SUBJECT: REVIEW OF PRELIMINARY ACCIDENT SEQUENCE PRECURSOR ANALYSIS OF EVENT AT  
ARKNASAS NUCLEAR ONE - UNIT 1

**LER No. 313/95-005**

Event Description: Trip with one Emergency Feedwater (EFW) train unavailable

## Licensee Comments

Fig. 2 ANO 1 Emergency Feedwater System.

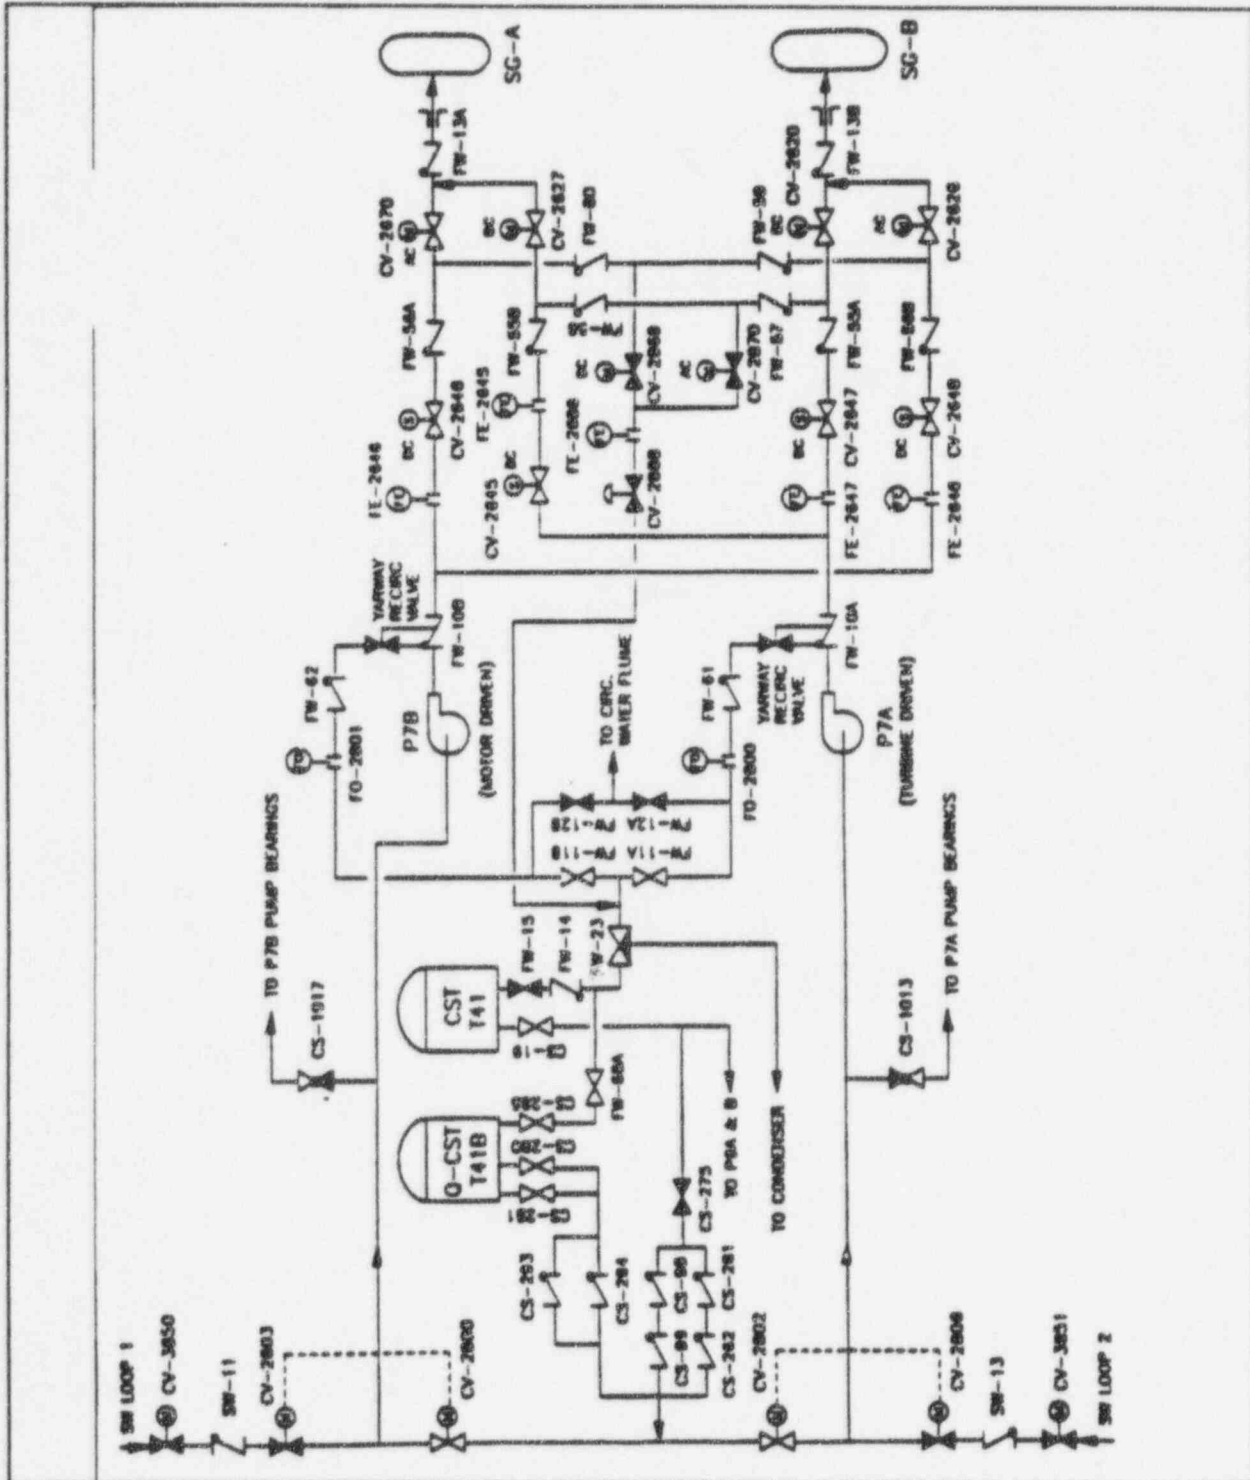
**Comment 2:** The event description states that control of the atmospheric dump valve was lost. Adding the word "remote" to the description clarifies that local control was still available. The same clarification may be added in the Additional Event-Related Information section.

**Response 2:** This clarification has been made. The sentence in the **Event Description** has been changed to (change noted in italics) "Train A SG level indication was lost, as was *remote* control of atmospheric dump valve (ADV) CV-2668 and emergency feedwater valves CV-2646 and CV-2648 (see Fig. 2)." The sentence in the **Additional Event-Related Information** section has been changed to "The failure of the +5 Volt power supply resulted in the loss of EFW flow control valves in the MDEFWP train (CV-

2646 and CV-2648) and ADV CV-2668 control in either automatic or manual control (*local control of the ADV was still possible*)."

Fig. 3. Dominant core damage sequence for LER 313/95-005.

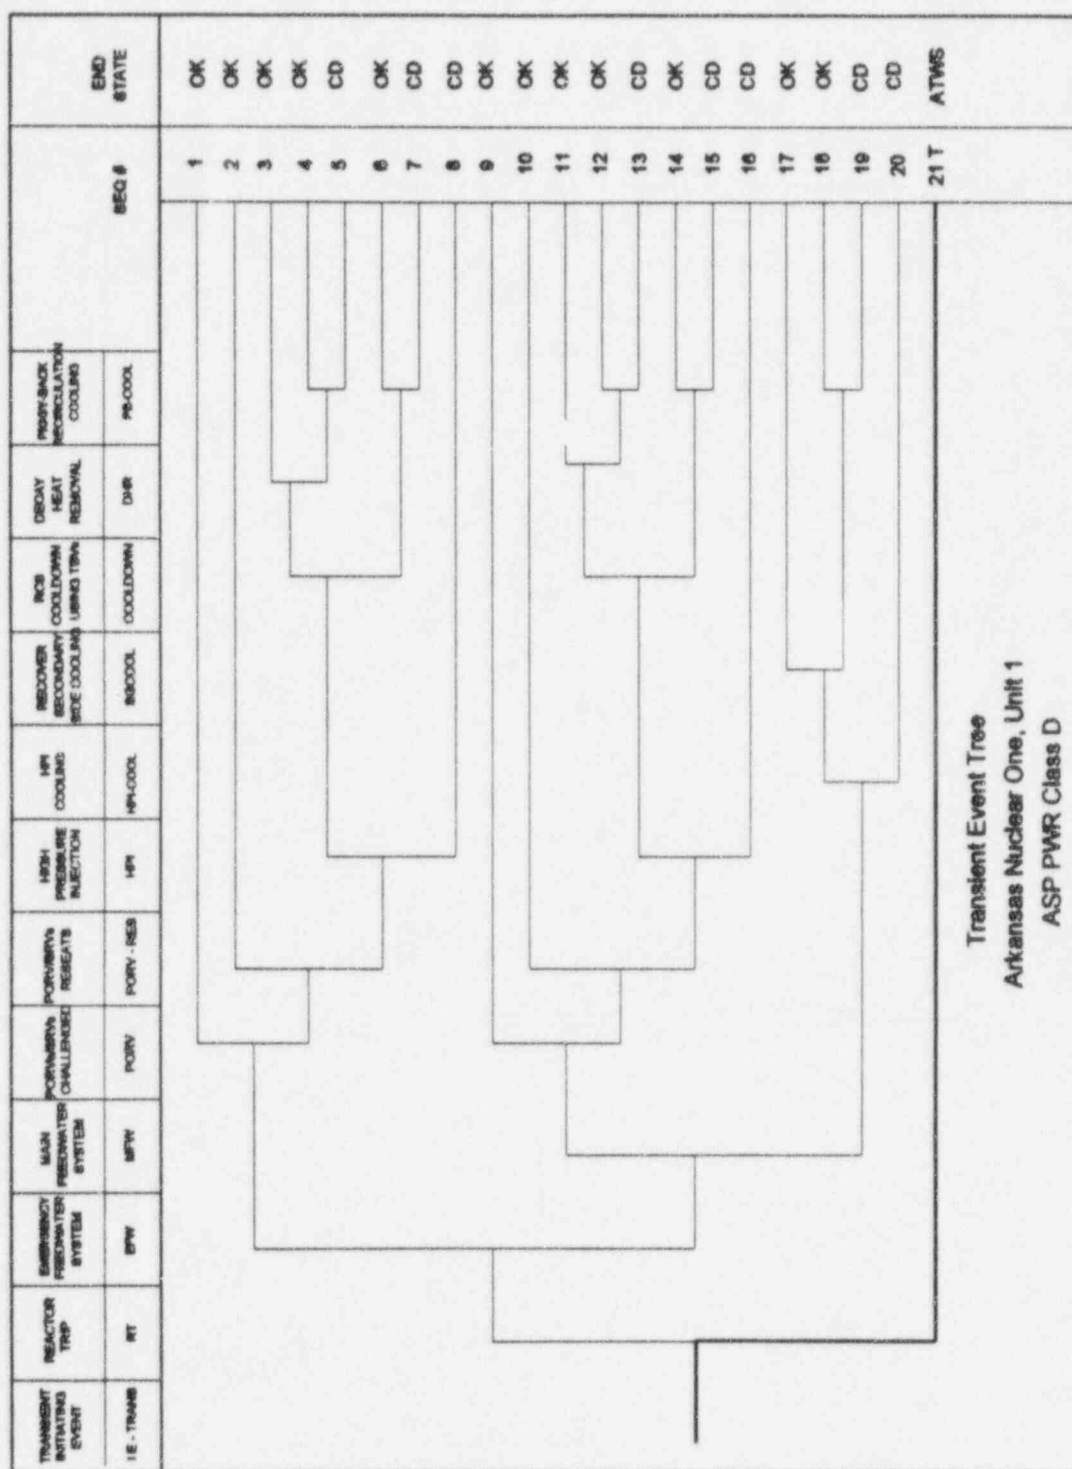
**Comment 4:** Upon evaluating the event description, and reviewing the Event Tree and resulting cut sets, it was identified that credit was not given for use of ANO-1's Auxiliary (Startup) Feedwater Pump (P-75). The Auxiliary Feedwater pump is an electric motor-driven centrifugal pump that is normally used during startup and shutdown conditions when there is insufficient steam available to run the main feed pumps. This pump is credited in the ANO-1 PSA as a recovery. . . .

The auxiliary feedwater pump can be credited in all transient sequences except for Loss of Offsite Power and Loss of Power Conversion System. The probability of failure for this recovery includes a mechanical failure probability as well as an operator failure. ANO-1's success criteria regarding the transient sequences involving loss of all feedwater defines an available time of 36 minutes for Loss of Power Conversion System sequences with reactor coolant pumps still running. . . .

**Comment 5:** TRANS Sequence 20: The probability of failure for the Aux. Feed pump as a recovery can be applied to all cut sets in this sequence. . . .

TRANS Sequence 21-8: The cut set for this sequence includes a failure of the EFW system. Therefore, the Aux. Feedwater recovery can be applied. . . .

**Response 4:** The event has been reanalyzed, giving credit for recovering the main feedwater supply using the motor-driven startup feedwater pump. The nonrecovery probability for the main feedwater system (MFW-XHE-NOREC) was changed to reflect this. The procedures supplied with the comment letter indicate that two valves must close, at least one of these valves must re-open, and the motor-driven pump must start and run for the recovery to be successful. In addition, adequate suction supply must be provided and operators must manually (remotely) align and start the system. The system failure probability given in Attachment 1 to the comment letter (1.6E-02) was used in the reanalysis.

**Response 5:** Credit for the MDSFWP is accounted for in TRANS Sequence 20 through the recovery of the MFW system (MFW-XHE-NOREC). The nonrecovery probability provided by ANO 1 (0.016—see Comment 4) was used rather than a typical recovery class R2 nonrecovery probability (0.34), as given in Appendix A in NUREG/CR-4674, Vol. 21.

ATWS sequences, such as TRANS Sequence 21-8, require emergency feedwater in a very short amount of time. The procedures supplied with the comment letter indicate that two valves must close, at least one of these valves must re-open, and the motor-driven pump must start and run for the recovery to be successful. In addition, adequate suction supply must be provided and operators must manually (remotely) align and start the system. Because of the time available for recovery actions, credit for the MDSFWP was given in the recovery of MFW, but not in the recovery of EFW.
